SPACE SHUTTLE HYDRAULIC SYSTEMS ASSESSMENT

Report number MDC J4610

Issue date 11 AUGUST 1978 Contract number NAS9-15550

FIGURE 3-20. R/SB SWITCHING VALVE MANIFOLD AND UNIONS

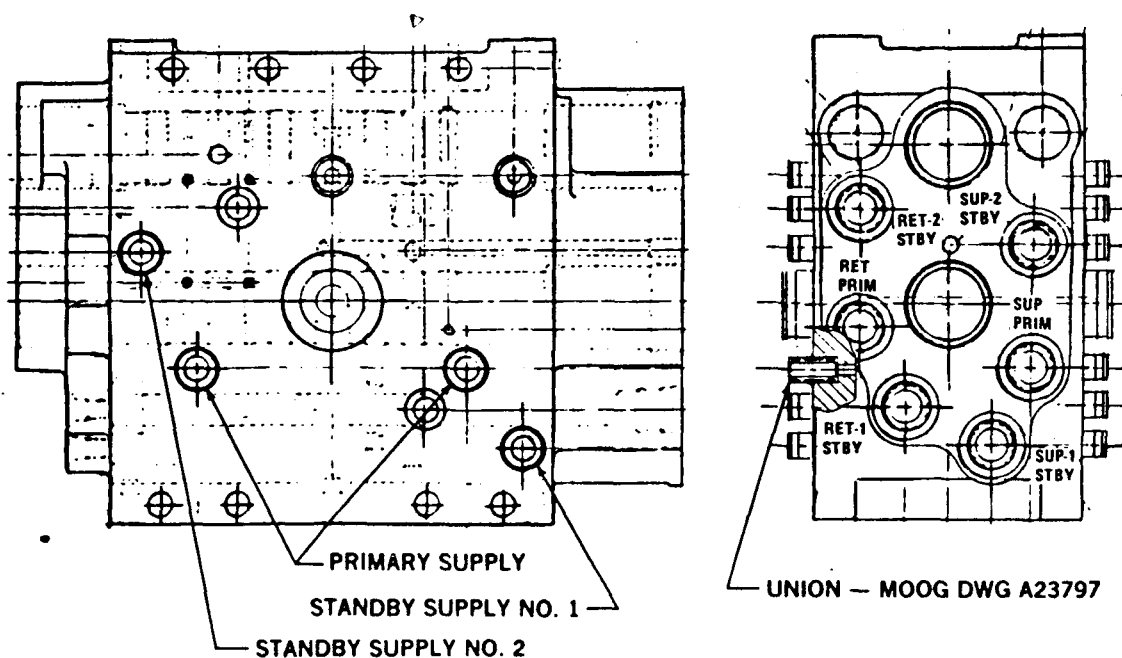
3.3.3.8 Failure of Rudder/Speed Brake Switching Valve Manifold Union T-Seals — Four unions (Moog Drawing No. A23797) called for in the hydraulic valve module assembly Drawing No. A23830 (see Figure 3-20) are used to transfer hydraulic supply pressure fluids from the switching valve manifold to the rudder power valve manifold, and an additional four unions are used to transfer supply pressure fluids from the switching valve manifold to the speed brake power valve manifold. Primary supply pressure is transferred through two of the unions; first and second standby supply pressures are transferred through the two remaining unions of the four unions per mounting face.

A T-seal failure on one of these unions would allow supply pressure to seep between the manifolds, enlarging in area until the fluid finds its way overboard from between the

It is recommended that a union seal leakage test be made to determine the adequacy of the design. It is recommended that load relief be provided as was done in the case of the Orbiter servovalves — example Moog valve, Drawing No. A24055 — by undercutting the surface to prevent load buildup between the manifolds which could cause bolt failure and loss of three hydraulic systems.

This problem was reported to NASA-JSC and corrective action is being taken by undercutting the mounting face to provide load relief. No updated drawings have been provided to this assessment team.

FIGURE 3-22. HYDRAULIC MOTOR BRAKE ASSEMBLY

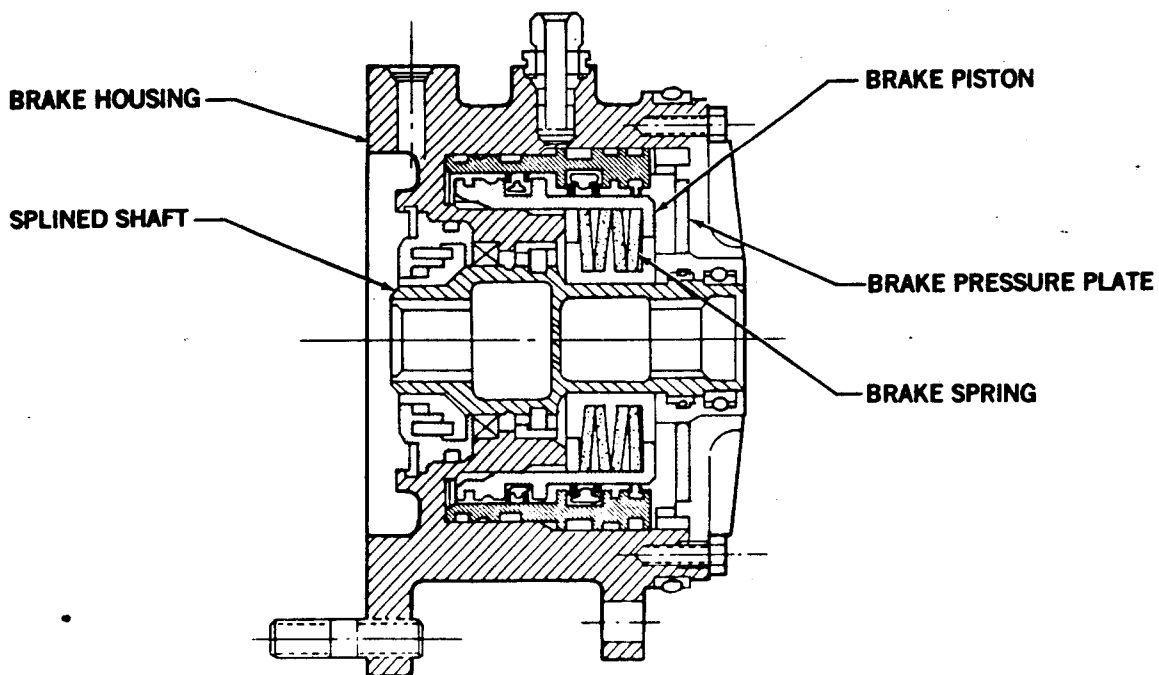
3.3.3.10 Hydraulic Motor Brake Fails in Off Position — The rudder/speed brake and body flap hydraulic control modules respond to electrical command signals to position a power valve which controls the flow of fluid to three independent hydraulic motors. The output velocities of the three hydraulic motors are mechanically summed through two differentials into a single output shaft to provide a drive into a mechanical mixer in the case of the rudder/speed brake and to the control surface in the case of the body flap. A hydraulic brake is employed at the output shaft of each hydraulic motor that is operated off the motor system pressure. At a predetermined decaying pressure, the brake is engaged to maintain the last commanded position of the control surface with no motor inputs and to prevent any torque from feeding back to the motor.

If a motor brake fails in the off position, then the two remaining motors will cause the failed system to run in reverse. This type of failure will cause loss of the vehicle, and is classified as Criticality Category 1U. It is an undetected failure and does not become apparent until after the supply pressure is lost. The body flap brake may be applied as often as two times per second; thus, many operational cycles can be applied to the hardware. A failure of the brake piston (Figure 3-22), pressure plate, or spring will prevent the brake from operating properly.

FIGURE 3-26 EXISTING RUDDER SPEED BRAKE DESIGN

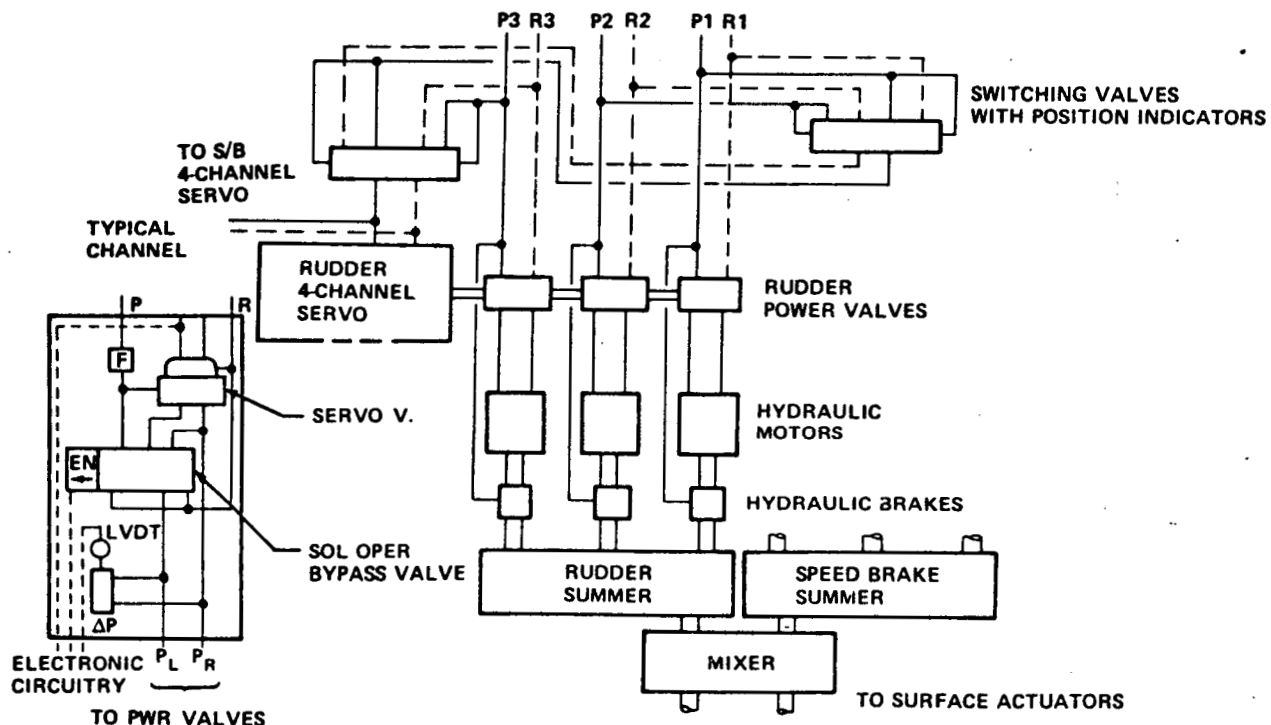
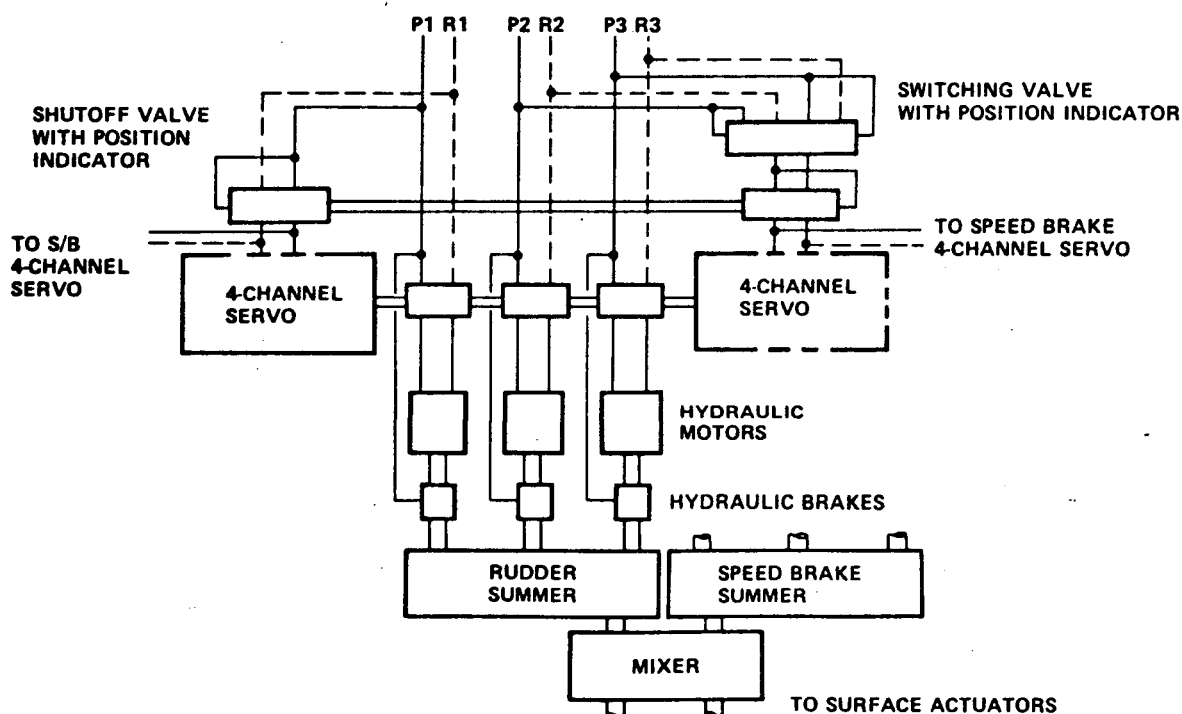
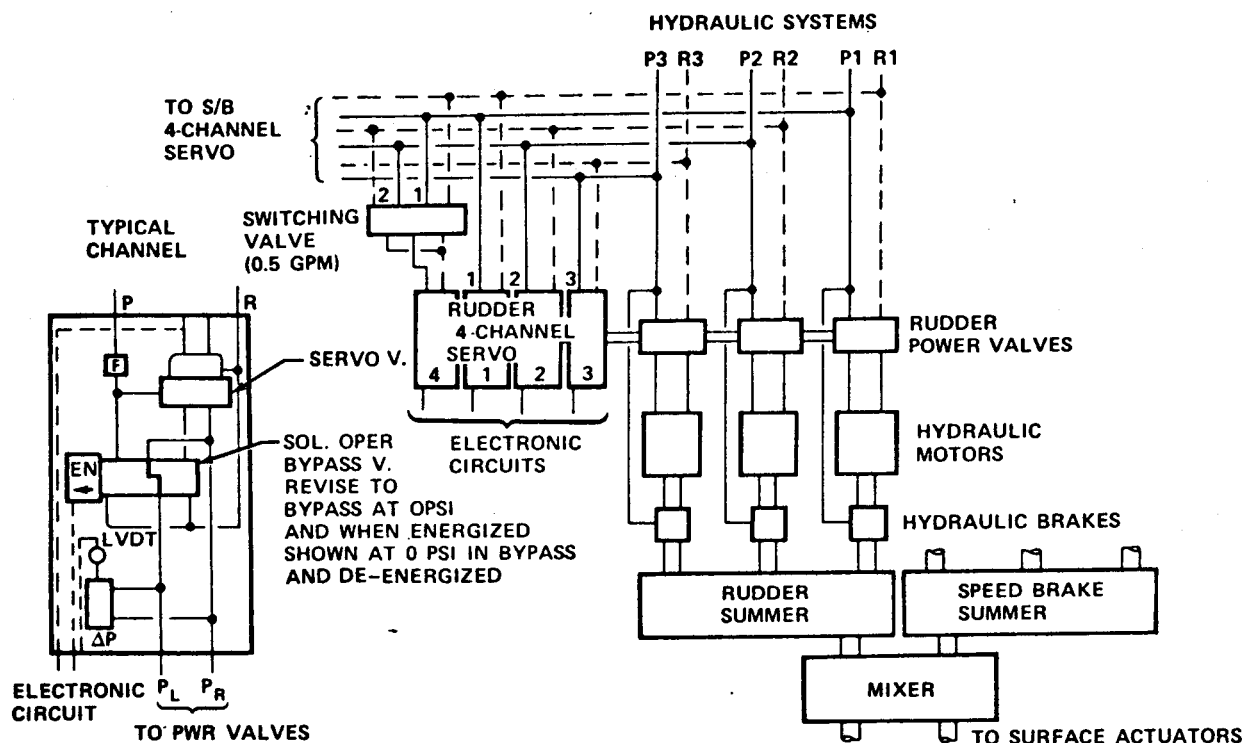
The existing design of the rudder/speed brake hydraulic operating system (Figure 3-26) incorporates dual hydraulic switching valves. These valves automatically select one of the two remaining redundant hydraulic systems, one after another, after failure of the primary system. The selected system supplies power to both the rudder four-channel servo system and the speed brake four-channel servo system. The hydraulic portion of each channel of each servo system consists of three hydraulic components: (1) a servo valve, (2) a pressure transducer, and (3) a solenoid-operated bypass valve.

As an alternate design, Rockwell proposed a tandem rudder/speed brake hydraulic power drive unit (Figure 3-27) which eliminated all the single failure points as a pressure vessel in the four-channel servos. This design eliminated one switching valve but incorporated an additional four-channel servo system. The avionics impact was large because this approach doubled the wiring and the aerosurface servo amplifier (ASA) hardware for the rudder/speed brake actuation system. The quiescent flow was increased. The size, weight, and cost of the hydraulic PDU was increased.

McDonnell Douglas Corporation proposes a design (Figure 3-28) that eliminates all the single failure points as a pressure vessel in the rudder/speed brake hydraulic power drive unit. The 24 components in the two four-channel servos will no longer be Criticality Category 1 items. This design eliminates the two existing large switching valves. The

FIGURE 3-29. EXISTING DESIGN OF ELEVON ACTUATOR

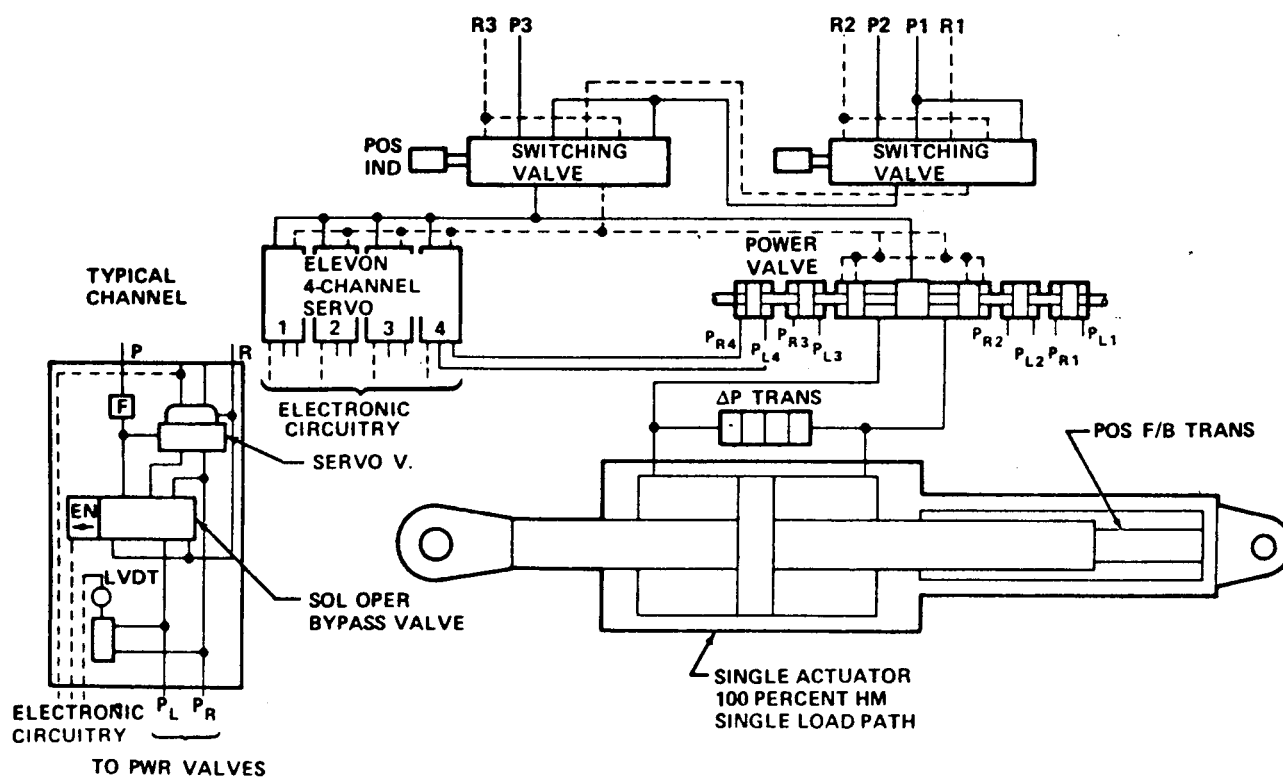
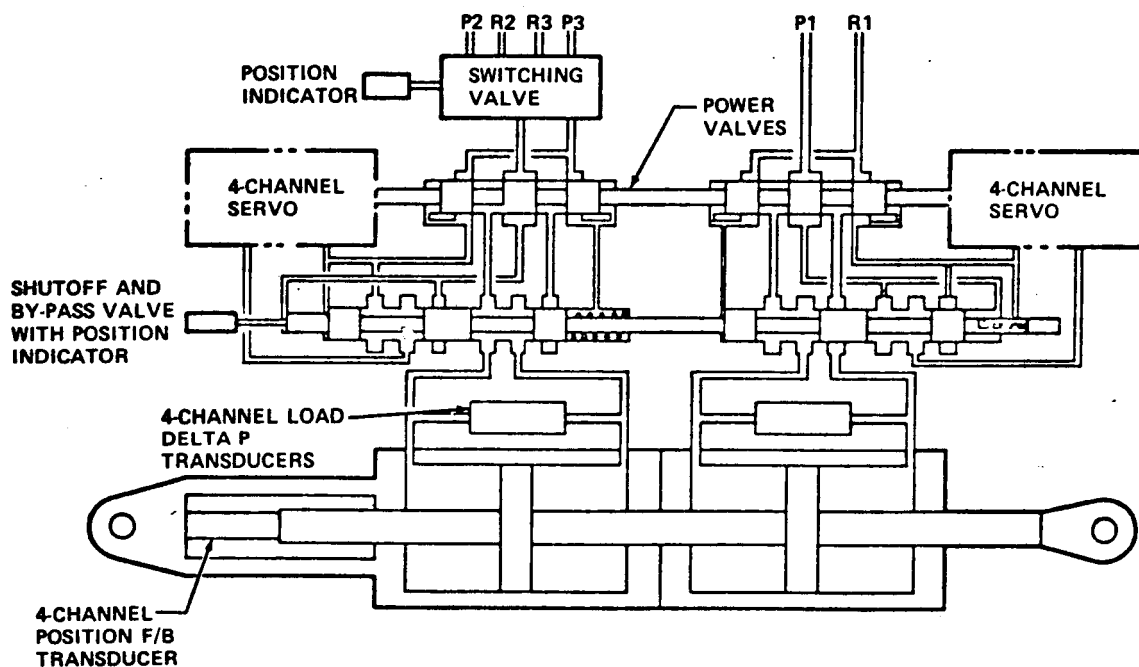
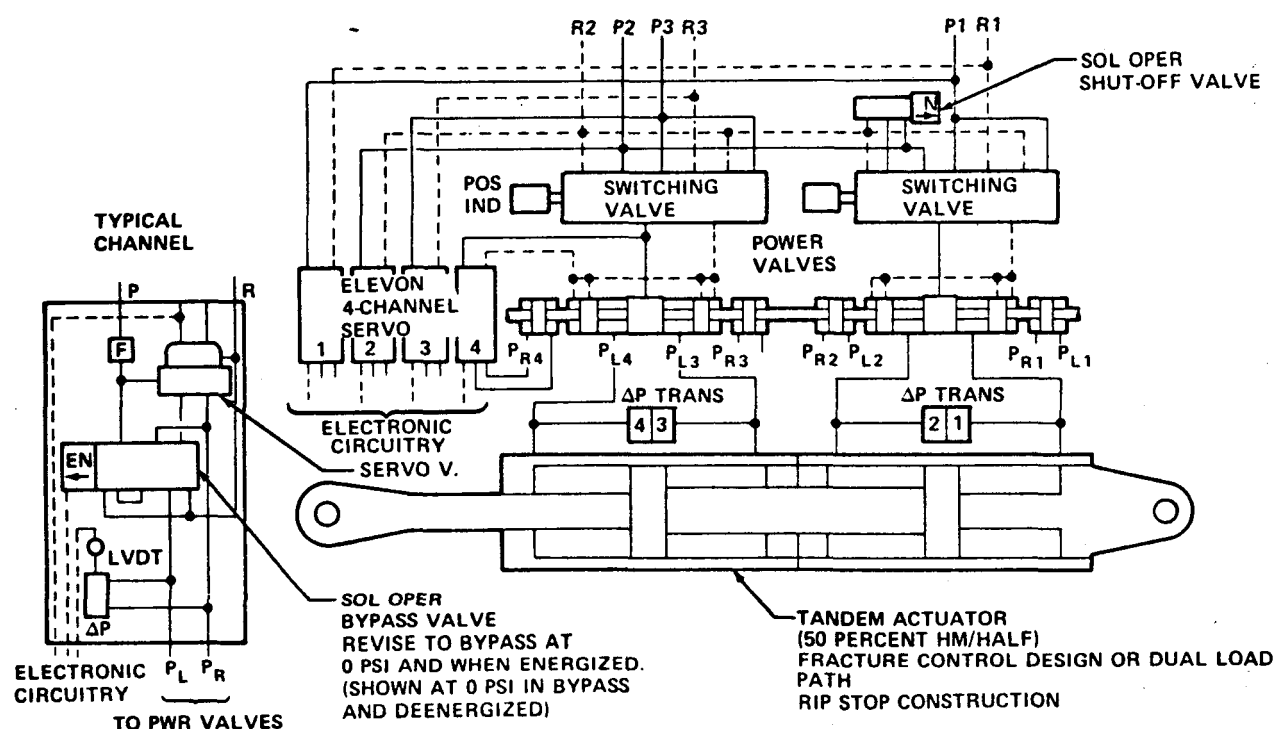
3.3.4.2.9 Elevon Actuation — The possible single failure points downstream of the switching valves in each elevon actuator package which can cause loss of all three hydraulic systems and result in loss of the Orbiter are too numerous to identify and avoid by overdesign and superior inspection procedures. There are four single type actuator packages, each of which drives one elevon surface. Each existing elevon actuator package (Figure 3-29) incorporates a four-channel servo which has 12 critical components, four dynamic feedback sensors, a switching valve manifold, a power valve manifold, and an actuator. This results in 19 critical components in each elevon actuator package, for a total of 76 critical components in the elevon actuation system, all of which

Rockwell proposed a tandem elevon actuator package design (Figure 3-30) that eliminated all the single failure points as a pressure vessel in the actuator packages. Although the material available does not specify rip-stop construction, it is assumed that the Rockwell design incorporated this feature as it is the only obvious method whereby all the single failure points could be eliminated in the proposed design.

McDonnell Douglas Corporation (MDC) proposes tandem actuator packages (Figure 3-31) which eliminate all the single failure points as a pressure vessel in the elevon actuator packages. The 76 components will no longer be Criticality Category 1 items. The proposed actuator packages incorporate rip-stop construction to prevent fracture propagation that might cause the loss of more than two (preferably only one) hydraulic system. Additional soft seals can be avoided by using a special sandwich-type construction employing brazing.

FIGURE 3-34. MCDONNELL DOUGLAS PROPOSED TANDEM ELEVON ACTUATOR

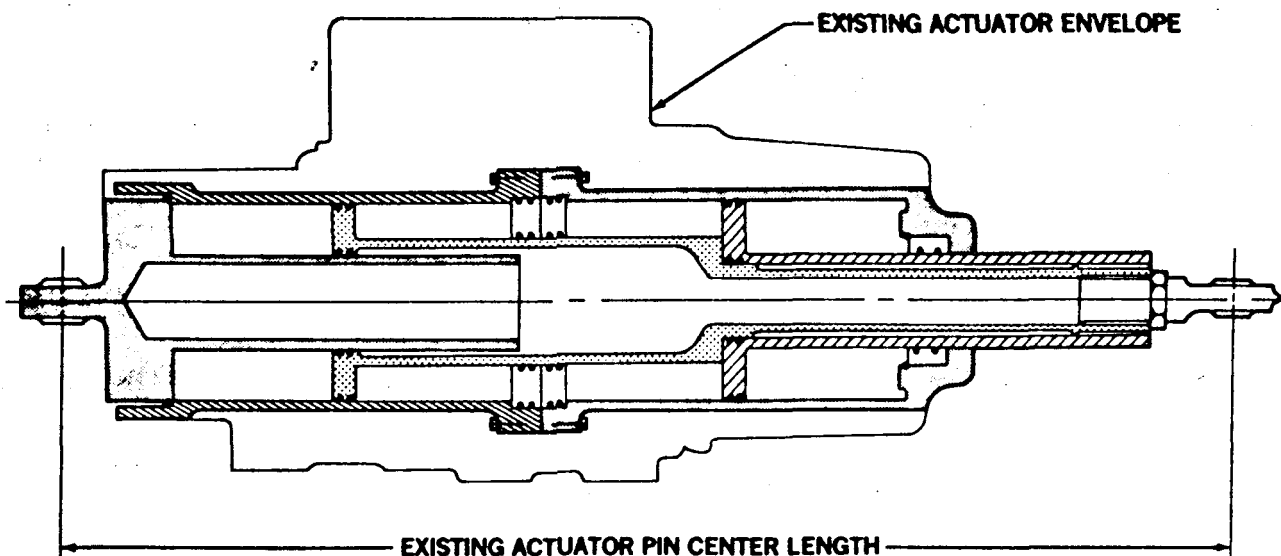
The MDC-proposed elevon tandem actuator packages (Figure 3-34) can be fit into the same envelopes as the existing single actuator packages. The same pin center lengths have been retained by use of an internal tail rod. The identical normal operating loads have been produced by balancing the actuator areas. The actuator is made smaller in diameter so that only 50 percent design hinge moment is produced by each half. Thus, the existing wing structure and support fittings can be used without change. The four-channel servo has been retained so that no change is required in the electronic circuitry or ASA hardware.

The proposed tandem actuator package retains two switching valves and a control valve. Another control valve and a small solenoid-operated shutoff valve have been added. It is recommended that a combination of a fracture control plan for part of the actuator and a dual load path for the remainder be incorporated.

R/SB SWITCHING VALVE MANIFOLD AND UNIONS

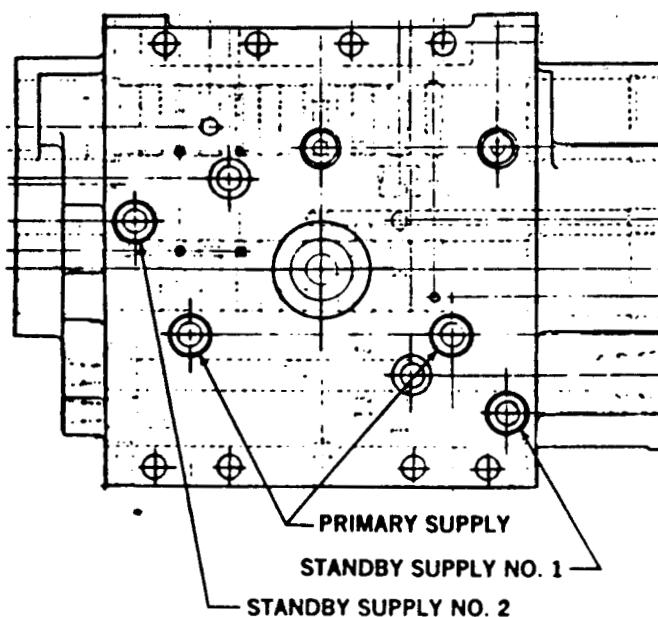
- SEAL FAILURE TEST SHOULD BE CONDUCTED TO VERIFY DESIGN.
- PROVIDE LOAD RELIEF TO PREVENT FORCE BUILDUP BETWEEN MANIFOLDS THAT COULD CAUSE BOLT FAILURE AND LOSS OF THREE HYDRAULIC SYSTEMS.
